Elf Mushroom Farm Project and Substrate Plant

*Part 3A Modification
Assessment*

*(CP 08_0255 MOD 2 and
MP 08_0255 MOD 2)*

August 2019

Figure 4 | Approved site layout (top) and proposed site layout (bottom).

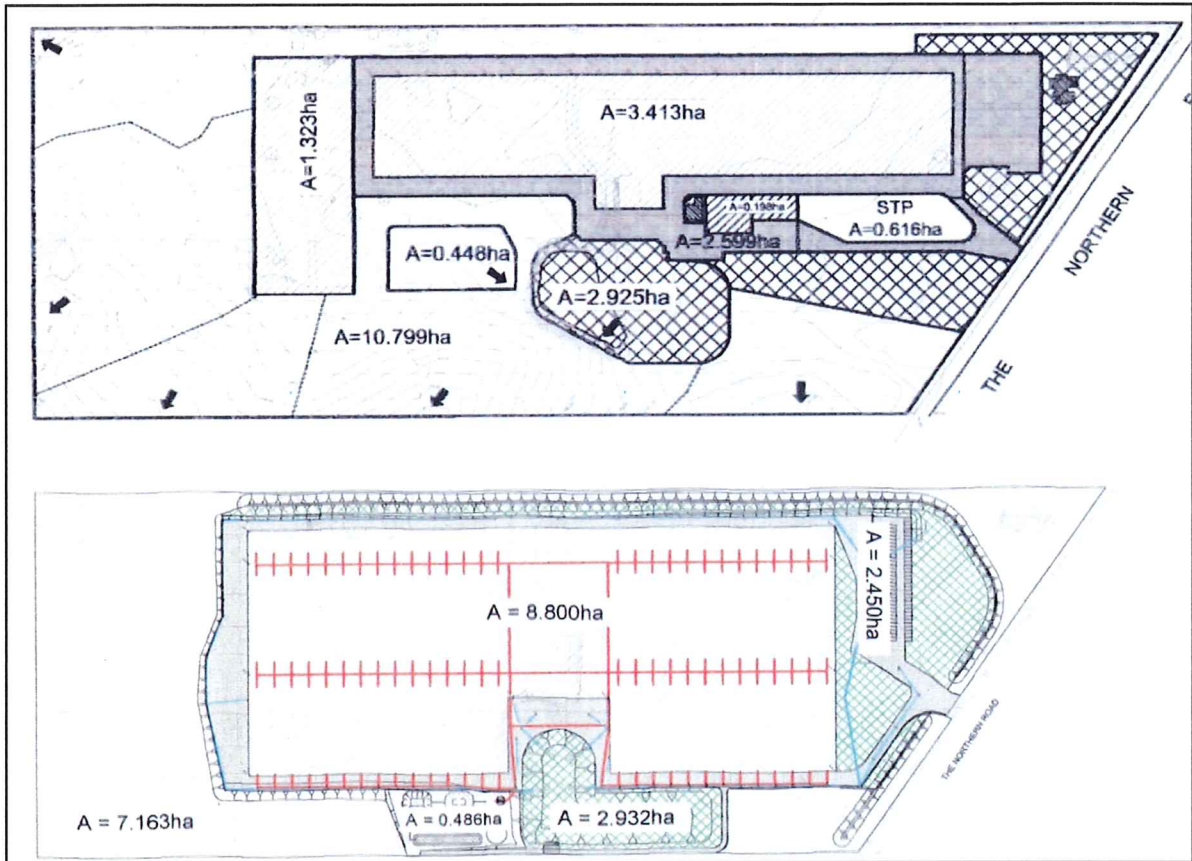
The number of growing rooms is proposed to increase from 55 to 66. The Proponent has confirmed that while the number of growing rooms will increase, there will be no increase in production. The Proponent has indicated that the new machinery and growing processes do not increase capacity because the efficiency gains are achieved in energy consumption per kilogram of production. Harvesting and post harvesting labour efficiencies are also gained because the new process allows a single harvester to harvest more mushrooms per hour through mechanisation/robotics. According to the proponent these efficiencies reduce the cost per kilogram to harvest mushrooms rather than increase mushroom yield. The proponent has also indicated that the morphology of the mushroom strain determines the length of the growing cycle, and for this reason mushroom production does not vary greatly between different mushroom growing systems.

The larger building footprint and associated expansive roof, will also lead to gains in energy efficiency as Solar Panels will be installed, and the rain water collected and reused for cooling towers, toilets, boilers and external hosing.

Figure 5 | Plan showing the approved building (in red) and amended building and final internal design.

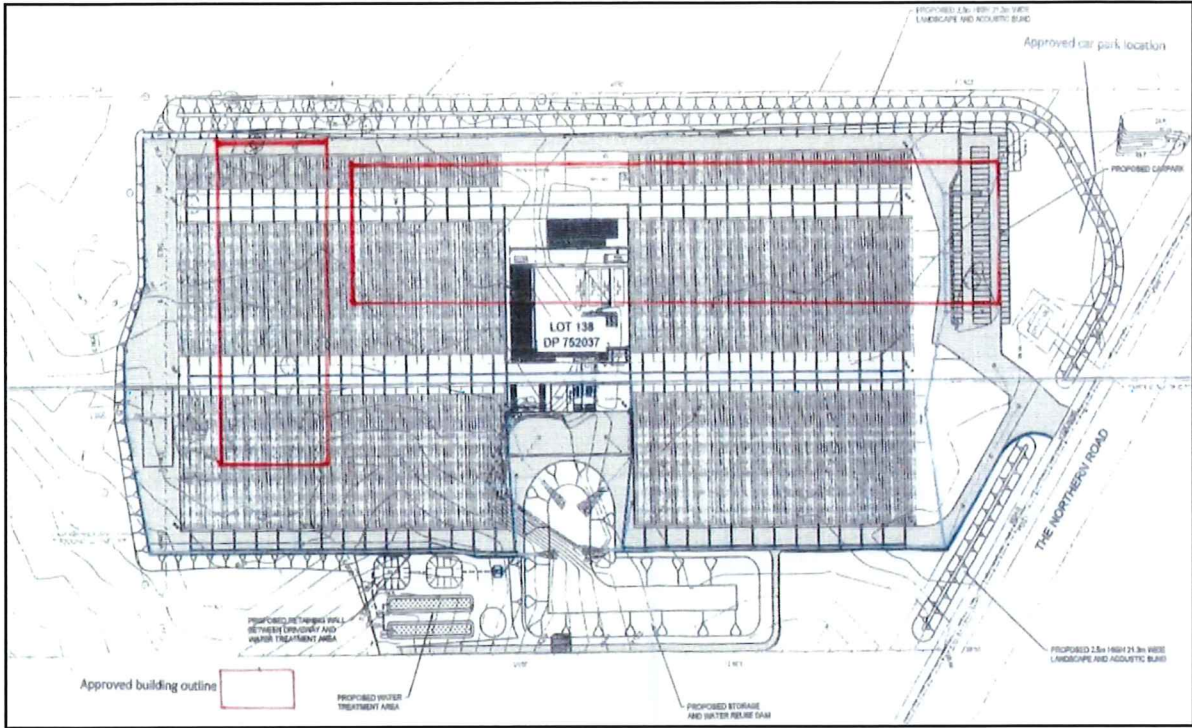
The key internal design changes include a small multi-level pre-harvesting growing room along the northern wall of the building. The pre-harvesting growing rooms now transition southwards to large single level harvesting rooms where the 1st/2nd flush would be harvested and the crop winched to the southern side single level for the third flush harvest. The other key change involves the inclusion of another access corridor between the small and larger growing rooms which will ensure the filling of the growing rooms will be undertaken entirely indoors. According to the Proponent, the new design will not only reduce the potential for noise and visual impacts to the north, but will also assist in pathogen control and energy consumption leading to improved sustainability.

Figure 6 | Plan showing the reconfigured staging.

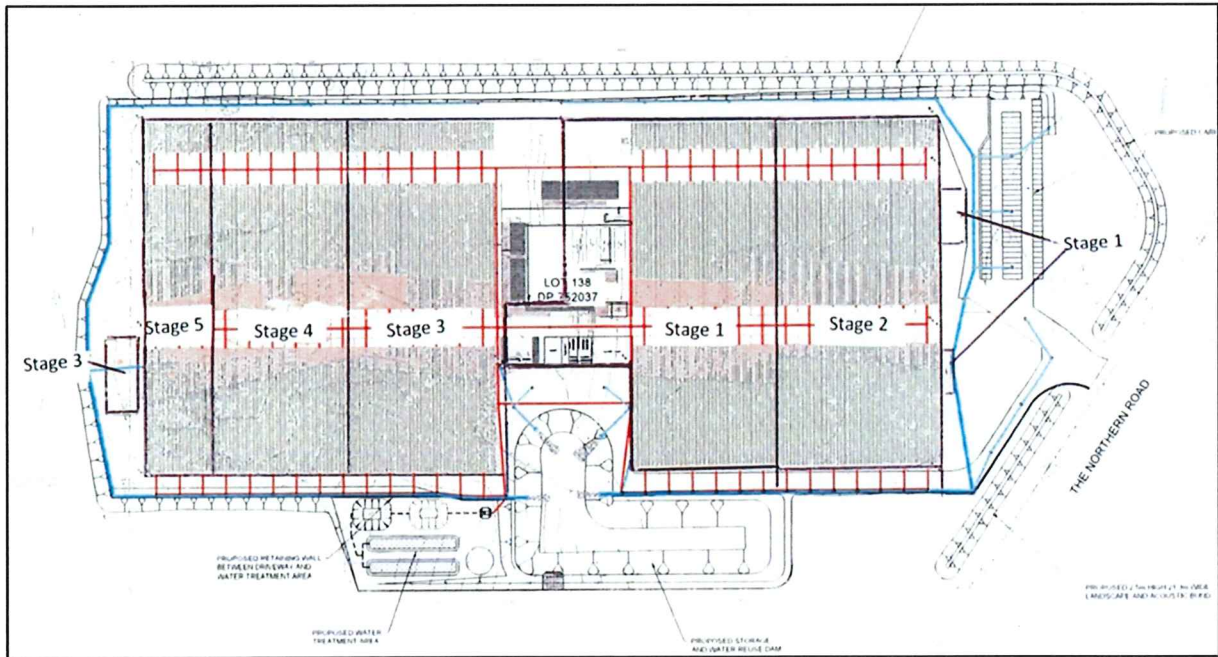
The reconfigured staging is identified in **Figure 6** below. Stage 1 comprises part of the front building containing six growing rooms including the staff amenities and packing area. The filling for the total building platform will also be completed in Stage 1. Stage 2 comprises the remainder of the front building containing seven growing rooms. Stage 3 comprises the front portion of the rear section of the growing building containing six growing rooms and the spent compost shed at the rear of the main building. Stage 4 comprises an addition to the Stage 3 building containing an additional six growing rooms. Stage 5 involves an addition to the Stage 4 building containing an additional three growing rooms.

Figure 6 | Approved building showing residential viewing points.

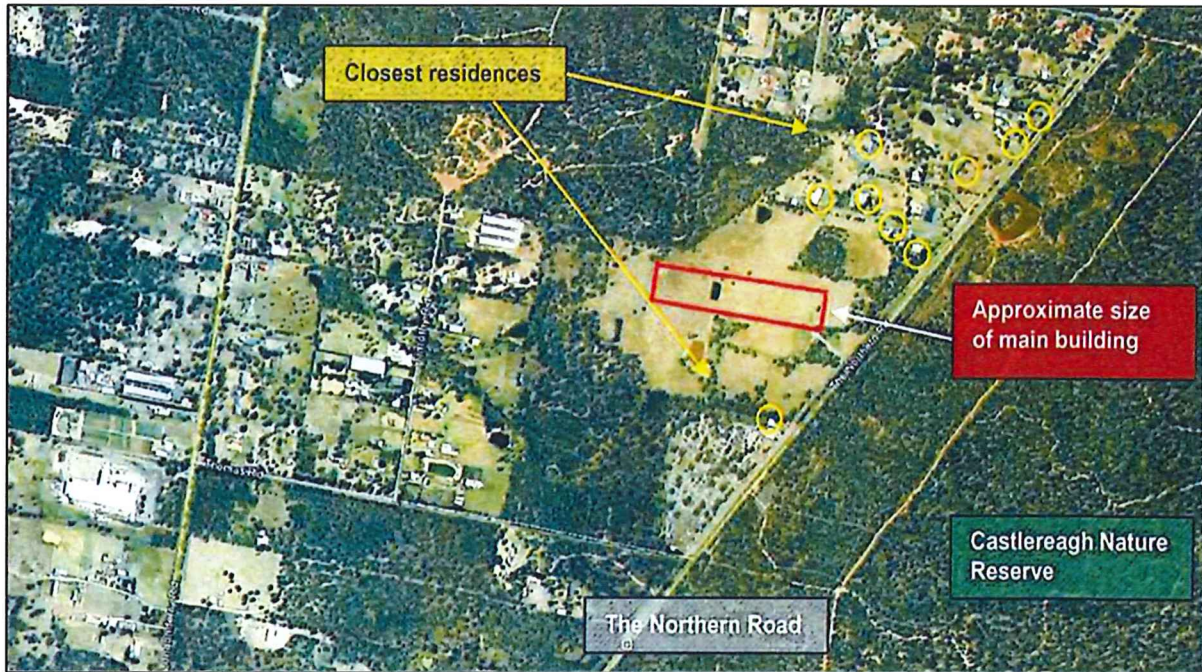
Significant concerns and objections have been raised relating to the increased size of the building, particularly from owners and occupiers of dwellings to the north and west. To the north, the nearest residence is approximately 150m away. These residences have views south across open paddocks to the proposed structure.

Whilst acknowledging the increase in size of the structure, the Department considers that there has not been a commensurate increase in impacts, particularly from the north and west. As can be ascertained from **Figure 6**, the visual impacts associated with the increased size of the structure would generally be limited to views from the south and east. The viewing opportunities from the south are limited to the car wrecking yard and the associated dwelling known as R3. Views from the west are limited given the distance and vegetation between viewing opportunities and the western end of the structure (refer to **Figure 6**).

The Department considers additional conditions are not required to mitigate the visual impacts of the proposal, but to add strength to the existing conditions, it is recommended that the required Landscape Plan must specifically provide for the early planting of advanced plants and trees along the northern and eastern boundaries to help screen and soften the expanse of the main structure.

Figure 9 | Cross section showing 31.5790m setback to the northern boundary

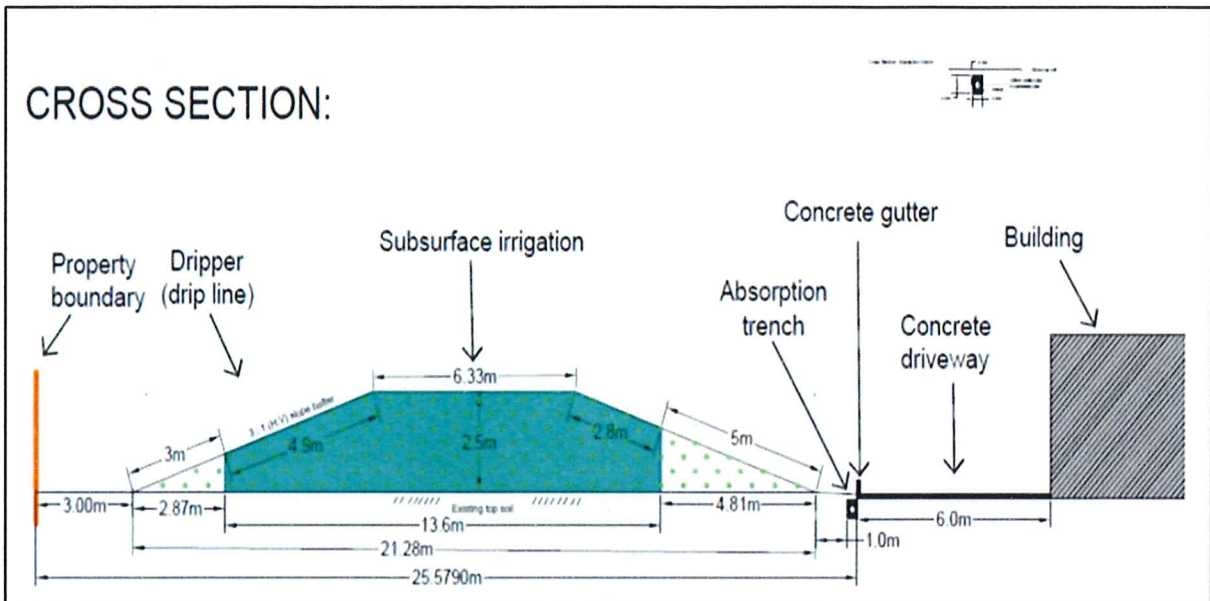
Initially the Department raised similar concerns to those raised by Council requesting additional justification on the basis that setbacks appeared insufficient relative to the size of the building and site boundaries. However, on closer investigation the Department considers that the setbacks are adequate (refer to **Table 4**). The narrowest of these setbacks which is the setback along the northern boundary remains unchanged and is relatively wide being 31.5790m from the edge of the building to the boundary (refer to **Figure 9**).

Council also considered that the front setback was not in keeping with the rural character of the area. As identified in **Table 4**, the eastern setback is slightly narrower at the southern boundary increasing to 180m wide in the northern half of the site.

The Department considers that the issue is less about setbacks and more about the increase in width of the building across the eastern boundary and how the building is viewed from The Northern Road noting that viewing opportunities from the nature reserve on the other side of The Northern Road would be limited.

The Department accepts that the building as viewed from The Northern Road will increase significantly in width. However, it is satisfied that there is sufficient setback to accommodate the proposed bund, extensive landscaping and appropriate architectural treatment that would mitigate this view. As previously indicated in **Section 5.1** of this report, early planting of advanced plants along the northern and eastern boundaries is conditioned to screen and soften the expanse of the main structure.
